SPORT JET 90 INFORMATION UPDATE

1993-1994 Sport Jet 90

S/N 0E009675 thru 0E095087

The following represents the most common customer and/or dealer problems and solutions on 1993-1994 Sport Jets.

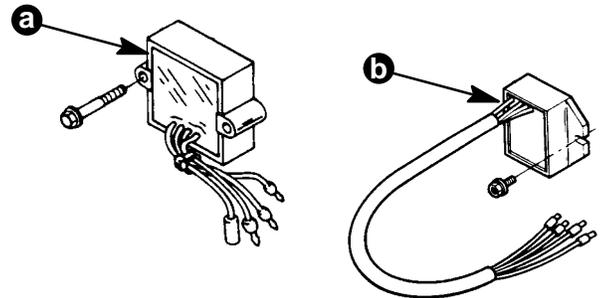
The starter pinion would engage then quickly disengage the flywheel. This condition was resolved by a starter containing stronger magnets. The part number for the new starter is 819968-1. This starter was first used in the Sport Jets at serial number 0E066991.

a - New Regulator
b - Old Regulator

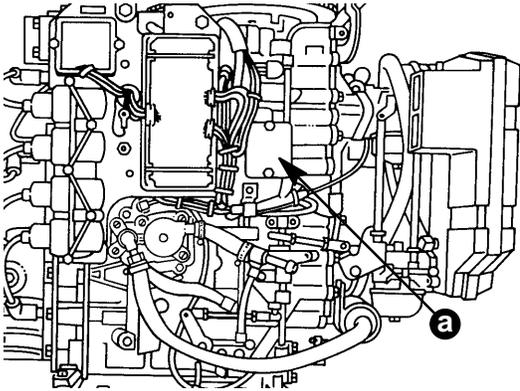
The voltage regulator has been identified as the cause of stator failures. New, higher capacity voltage regulators, listed below, have resolved stator failures. Sport Jets with serial numbers above 0E066619 have the latest regulators.

Should a stator failure occur between serial numbers 0E009675 and 0E066619 replace the stator (p/n 8778A29) and the voltage regulator. The proper voltage regulator is listed below:

S/N 0E009675 thru 0E033710

Use regulator p/n 815279T 3
(Ring style terminals)

S/N 0E033711 thru 0E066619

Use regulator p/n 815279T 5
(Bullet connector style terminals)
